STATE OF DELAWARE
DEPARTMENT OF TRANSPORTATION
800 BAY ROAD
P.O. BOX 778
DOVER, DELAWARE 19903

February 17, 2009

DelDOT Contract Number: 95-090-01; Federal Aid Project Number: IM-N056(27)
I-95 Delaware Turnpike Improvements Project
I-95/SR 1 Interchange/I-95 Turnpike Mainline
Turnpike Mainline from SR 1 to SR 141; I-95/SR 1 Interchange; I-95 Northbound
Widening Extension
New Castle County, Delaware
Environmental Reevaluation [*Change in interchange design*]

I-95 / SRI INTERCHANGE IMPROVEMENTS
 ENVIRONMENTAL REEVALUATION
FIGURE 3 (1 OF 5)
MODIFIED DESIGN

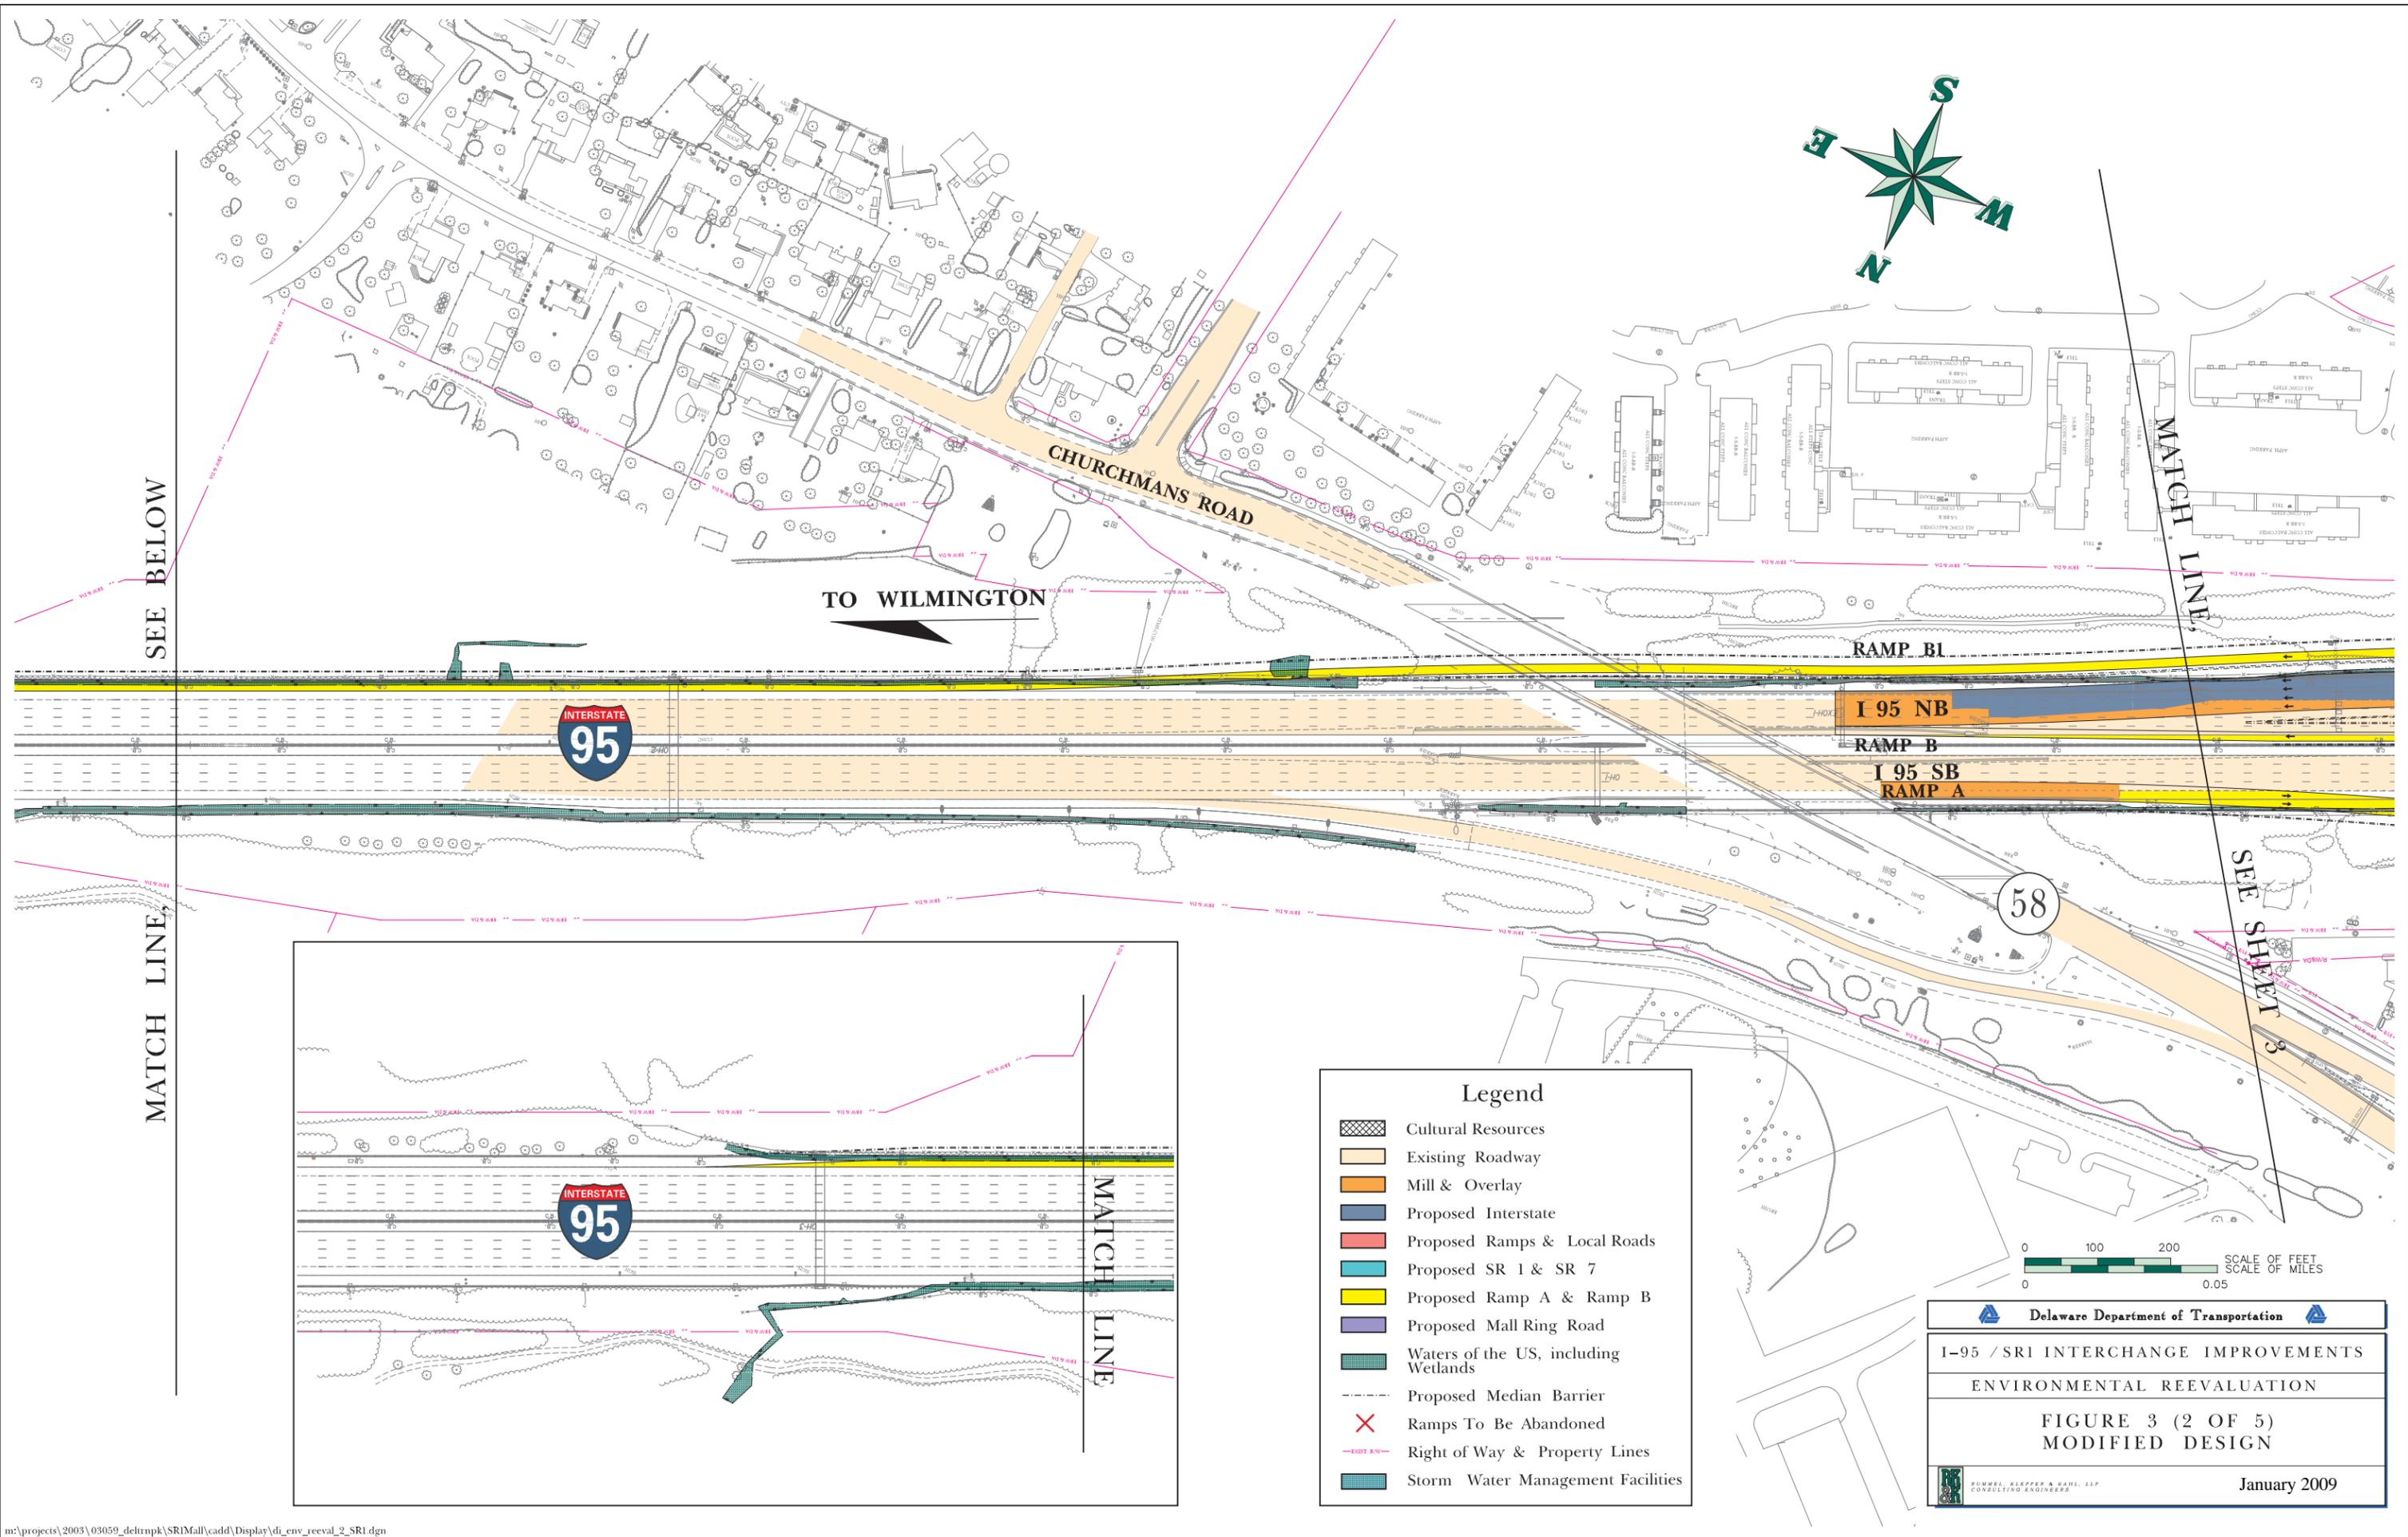
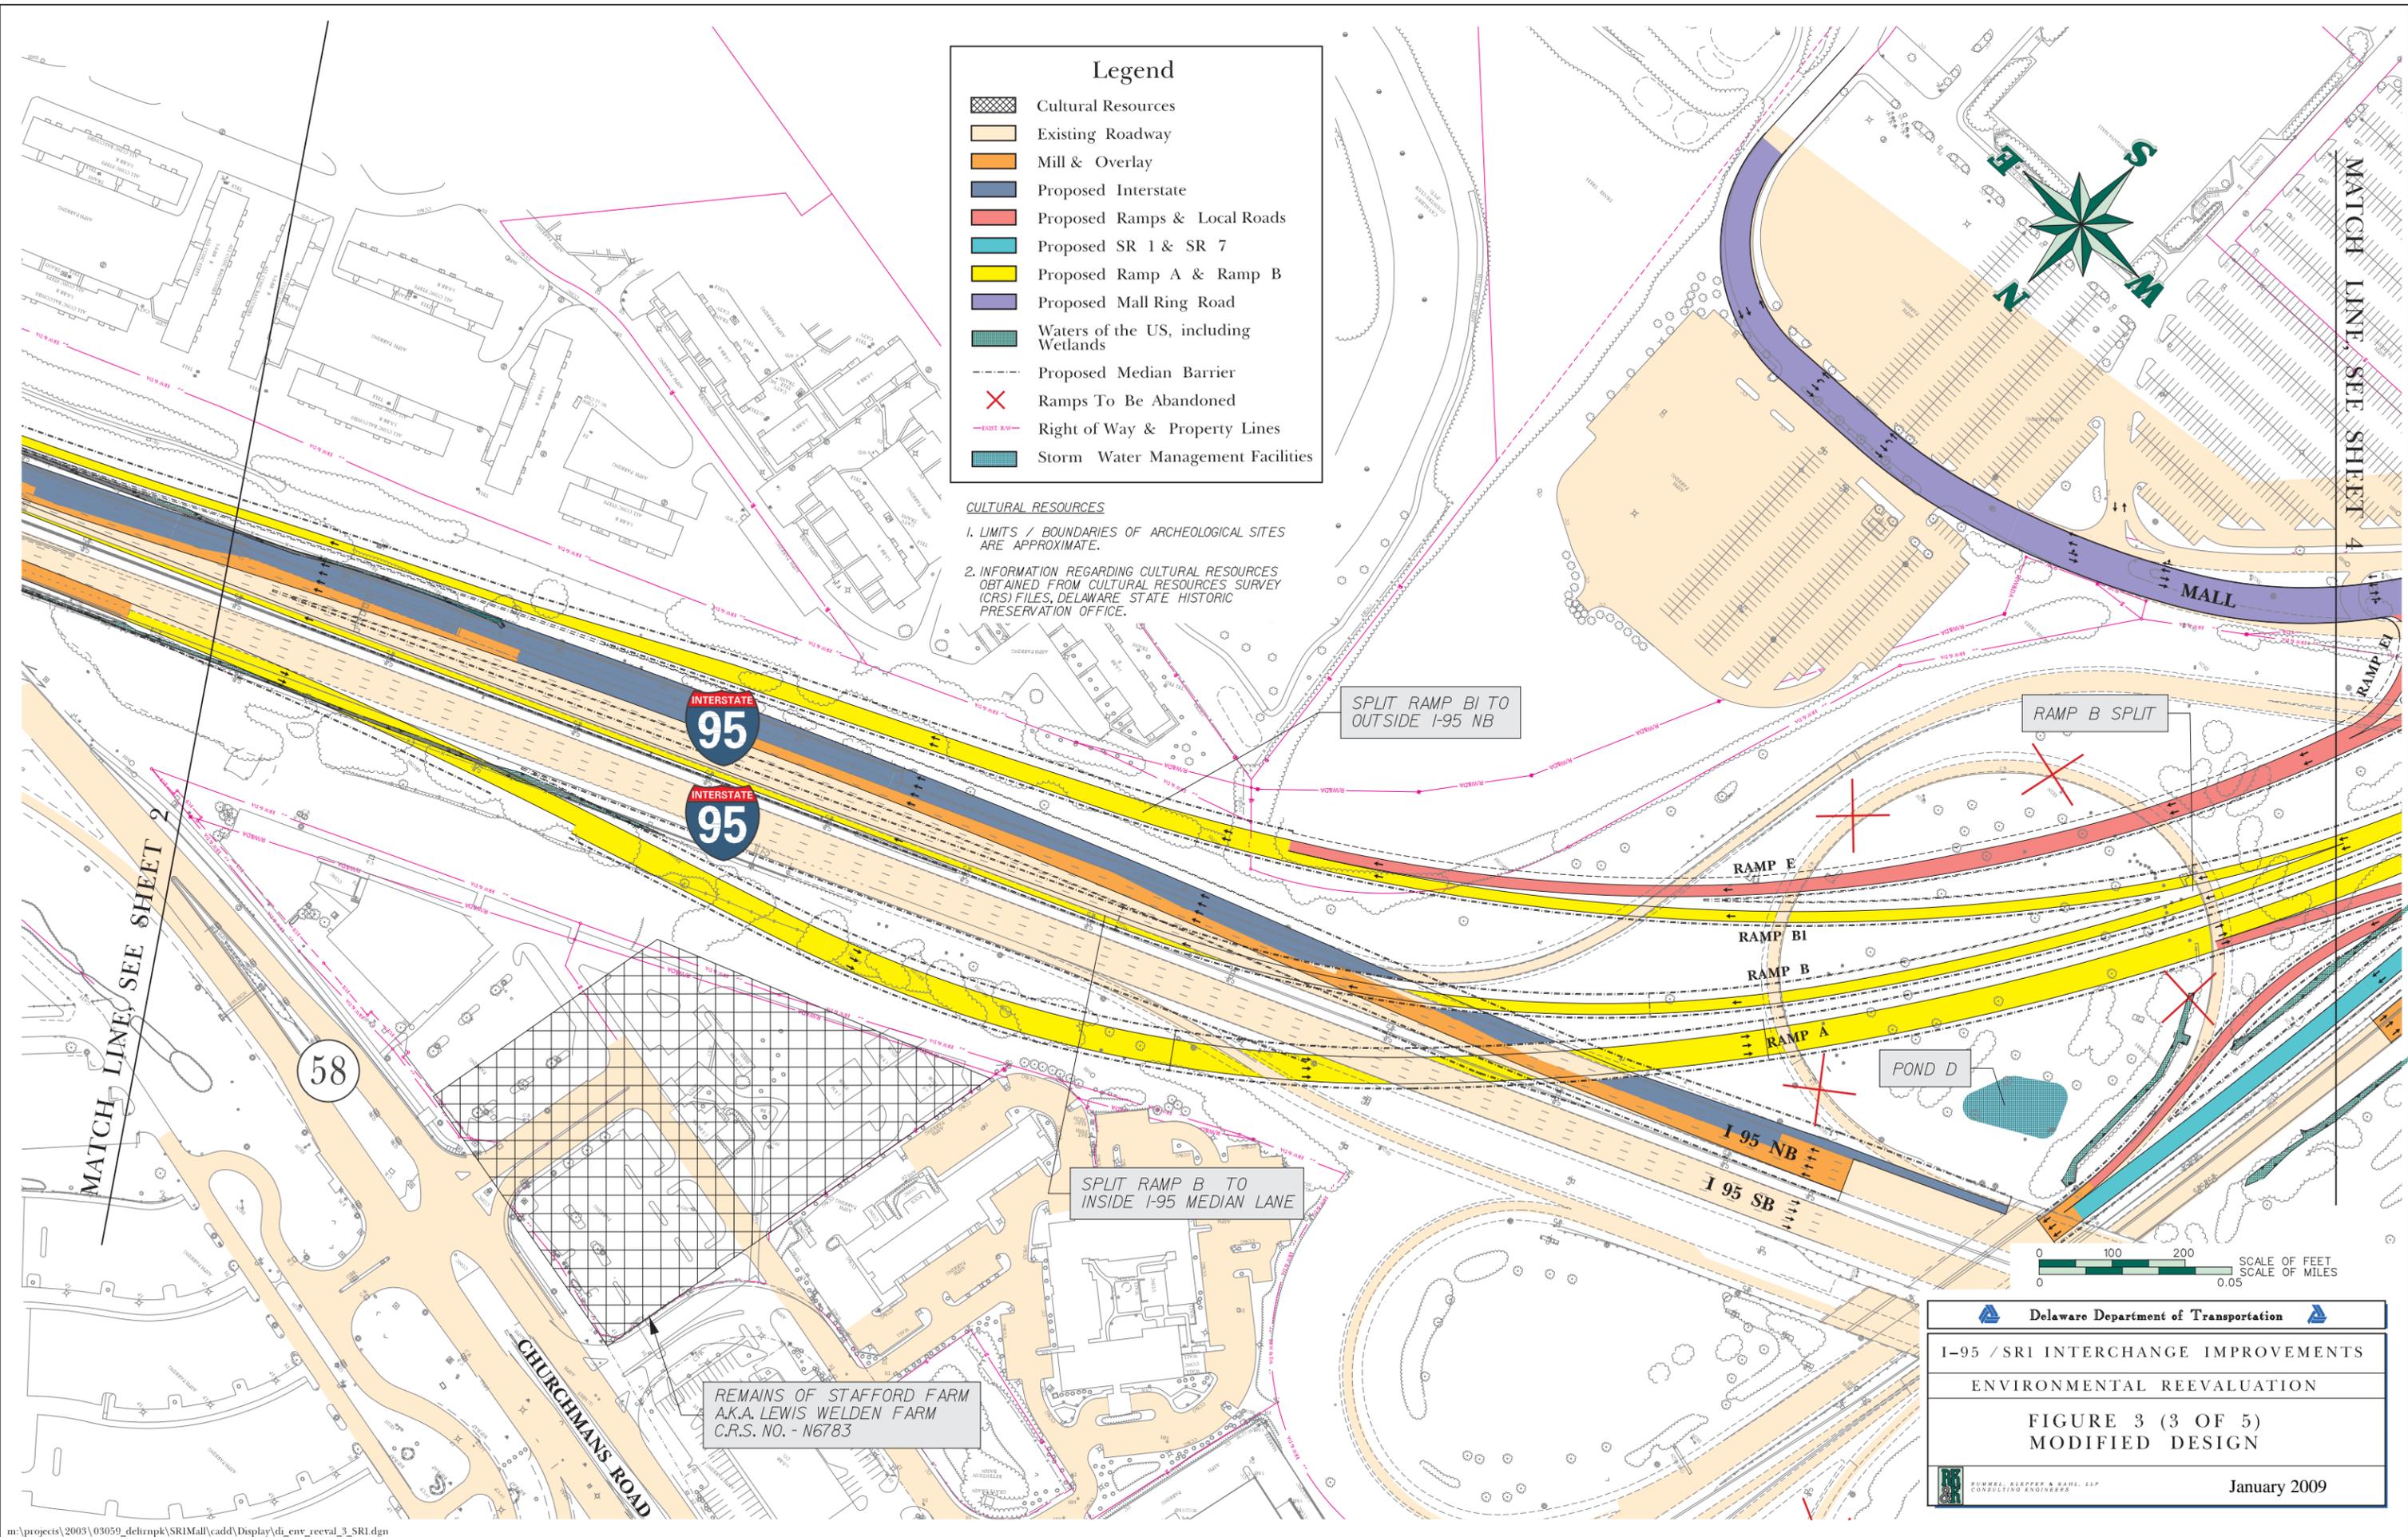
- The existing southeast quadrant loop ramp (from I-95 northbound to SR 7 northbound) has been eliminated and replaced by a semi-directional flyover ramp (identified on **Figure 3** as Ramp C) that extends from the southwest outer ramp from northbound I-95, passes over SR 7 and merges with northbound SR 7.

- The existing northbound lanes of I-95, north of the interchange, are shifted approximately 40 feet to the outside to accommodate Ramp B, which will fly over northbound I-95 and extend as the median lane of I-95.
- Ramp B (SR 1 northbound to I-95 northbound) will split in the vicinity of the southwest quadrant. The left lane will fly over northbound I-95, and become the median lane of the northbound I-95 mainline, as noted above. The right lane of Ramp B (Ramp B1) will extend along the outside of existing northbound I-95 and remain barrier-separated from the northbound I-95 mainline until north of the Churchmans Road bridge, where the lane merges with the existing outside mainline lane.
- The ramp (Ramp R1) to/from the Christiana Mall Road will be relocated approximately 150 feet south of its present location.

- The replacement of the southeast quadrant loop ramp with the directional flyover ramp from I-95 northbound to SR 7 northbound will eliminate the existing weave on northbound I-95, between the entry loop ramp to northbound I-95 from southbound SR 7 and the exit loop ramp from northbound I-95 to northbound SR 7.

- Shifting the I-95 mainline to the outside and bringing the split Ramp B (SR 1 northbound to I-95 northbound) into I-95 as the median lane of I-95 allows motorists from SR 1 destined for Wilmington to avoid having to weave across four lanes of I-95 within a distance of approximately four miles.

- The relocation of the Ramp R1 bridge approximately 150 feet to the south will allow for a lower profile for the ramp bridge and the reconstructed Christiana Mall Road, thus reducing the impact to the mall parking lot and eliminating a proposed retaining wall. Shoulder reductions in some areas have been reduced from 16/24 feet to 12 feet to accommodate the changes and avoid additional property acquisition from the Mall.

See **Figure 3** for locations of Ponds A-F.
